**POTOMAC HIGHLANDS AIRPORT AUTHORITY
MINERAL COUNTY, WEST VIRGINIA**

**REHABILITATE RUNWAY 5-23 BID PACKAGE 6
TAXIWAY A EXTENSION**

ADDENDUM #2

JUNE 22, 2023

SHEET No.	26
-----------	----

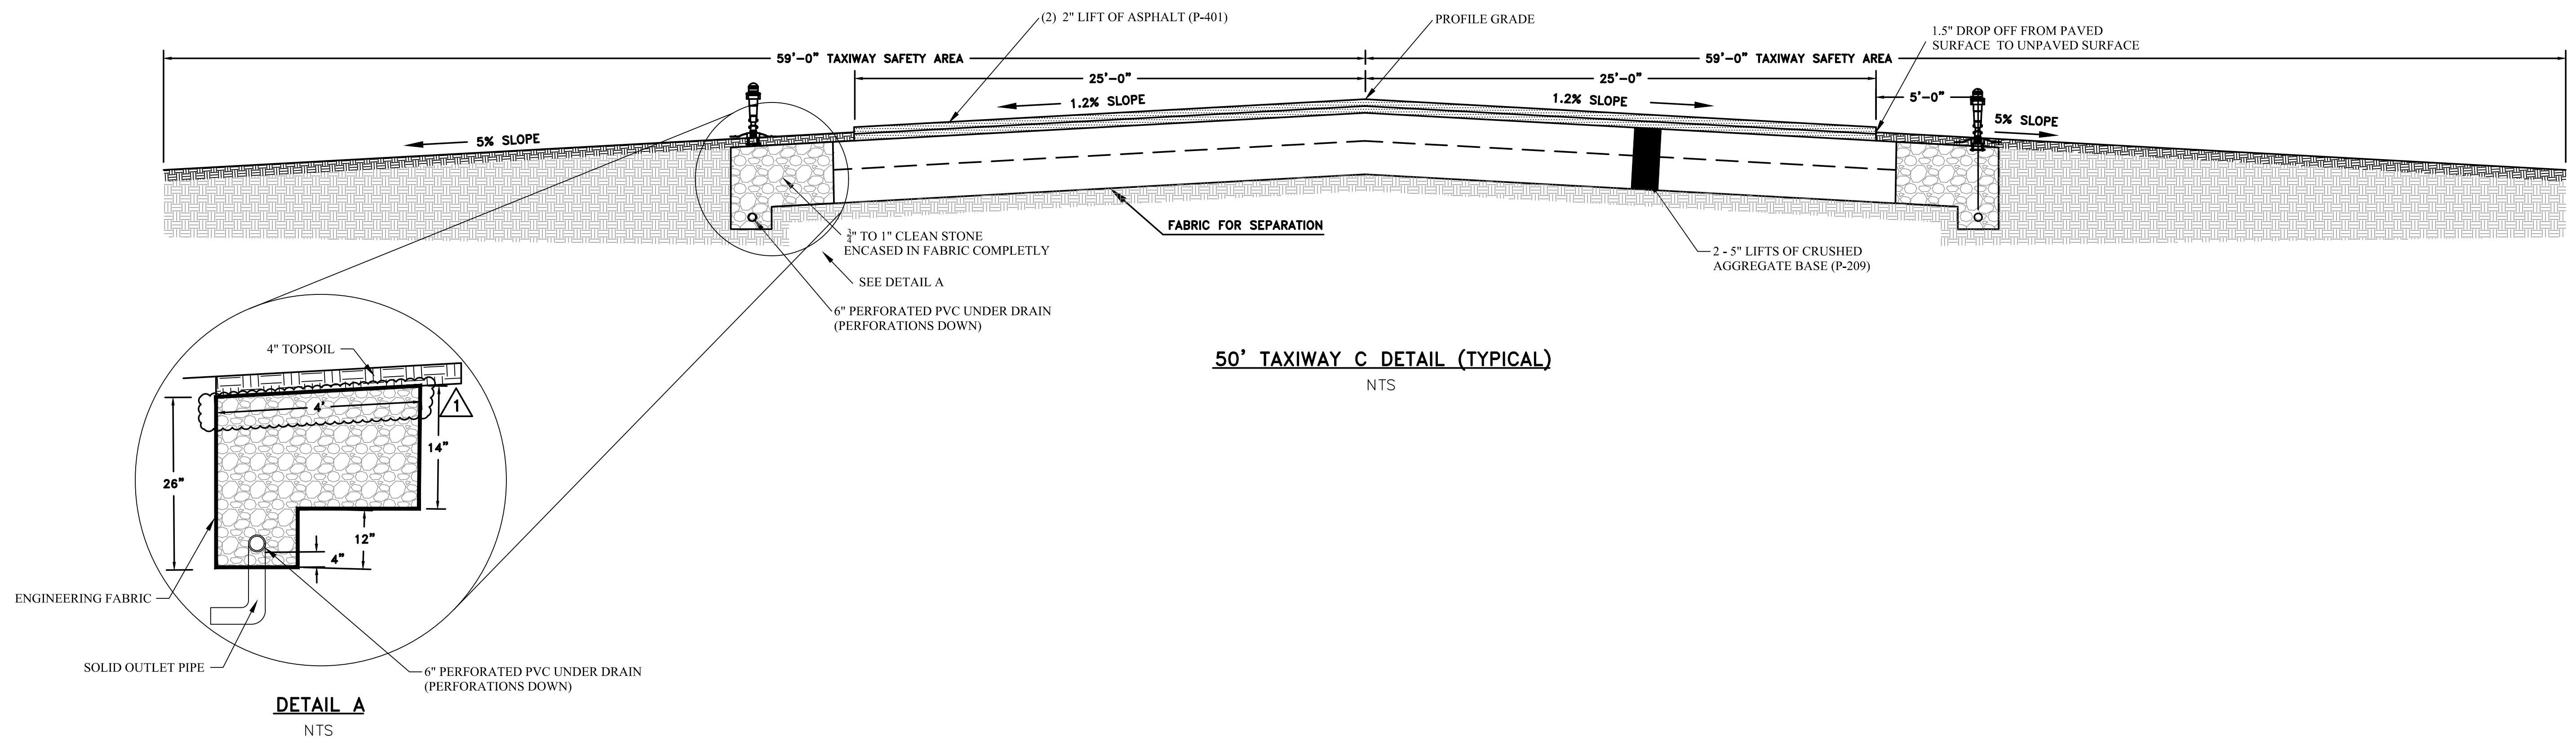
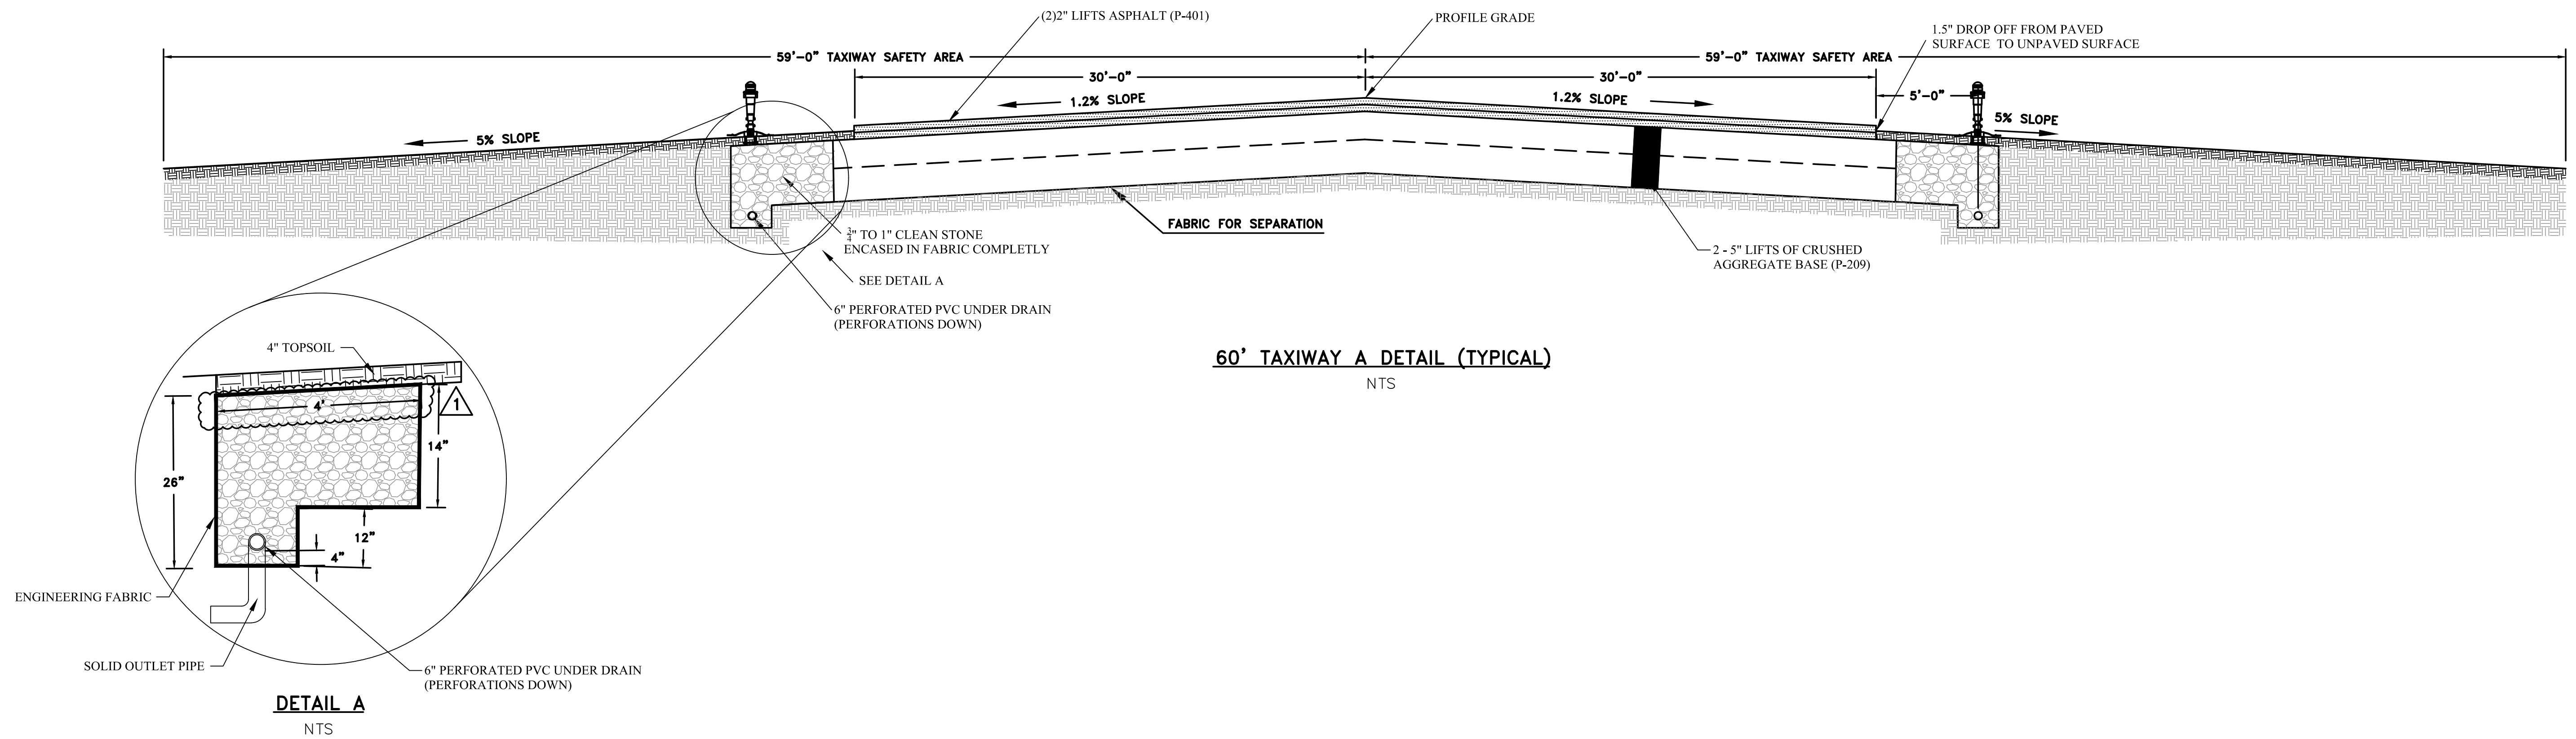
3. Can you provide dimensions on Detail A, Sheet 26, for the width across the top of the stone backfill.

1	NMJ	5/22/2023	ADDEDUM #2 - REVISION 1	ADDED DIMENSION TO DETAIL	
NO.	BY	DATE	DESCRIPTION

Detail has been revised on Sheet 26.
